Work Order ID 110953

Item Name: Bracket

WORK ORDER NON-CONFORMANCE / UPDATE

From: David Shepherd
Sent: Tuesday, April 15, 2014 6:01 PM
To: Roberto Fuentes; Eric Downing
Cc: Patrick Smith
Subject: RE: D4093

D4093-3 BRACKET

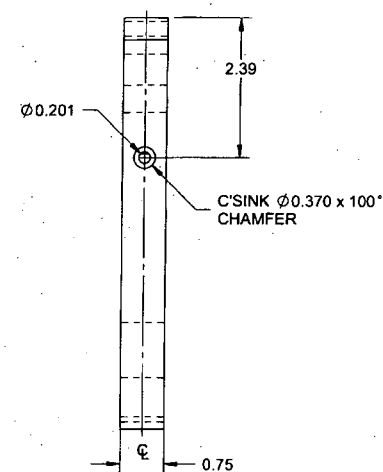
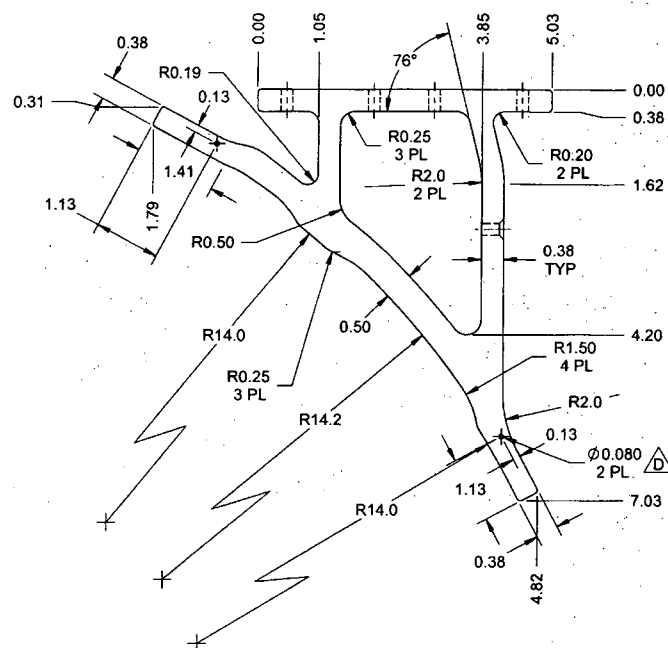
Root Cause	Date	Step	Qty	Description of work order update or non-conformance	Initial Chief Eng	Action Description	Sign & Date	Verification	QC Inspector
Design									
Doc/Data									
Equip/Tooling									
Handling/Pre									
Material									
Operator	14/04/16	130	X 20	0.080" holes found to be elongated to 0.101" x 0.080"	DAS 16 9-89	Drill holes out to 0.100" in DTA as per attached Email/ From DARTOS + Debur.		DAS 27 9-89	DAS 16 9-89
Offset/Setup				Re. supplier / water jet distortion cannot hold high accuracy on small holes. / was on DART DFX program.	14/04/16	Remove 0.080" hole from water jet program + perform by manual milling	14/05/15	14/05/12	14/04/16
Process									
Supplier									
Training									
Transport									
Unapproved

Could it be possible that we could open the holes to 0.100" to be able to remove the elongation?

Here you go I hope this helps. The elongation runs along the part not across it. And both holes are affected.

We have a run of D4093-3 that were out sourced for the water jet operation and the 0.080" wire holes are a bit elongated. They are measuring 0.080" across and 0.101" long.

I discussed with Roberto and I think the parts are acceptable as is.
If you want to open the holes to 0.100" to make them look better, then this would also be acceptable.

I like to check with David, I don't think elongation orientation is critical because is along the base. David is ok with that and you don't need to open to 0.100", it is just to run lock wire thru.
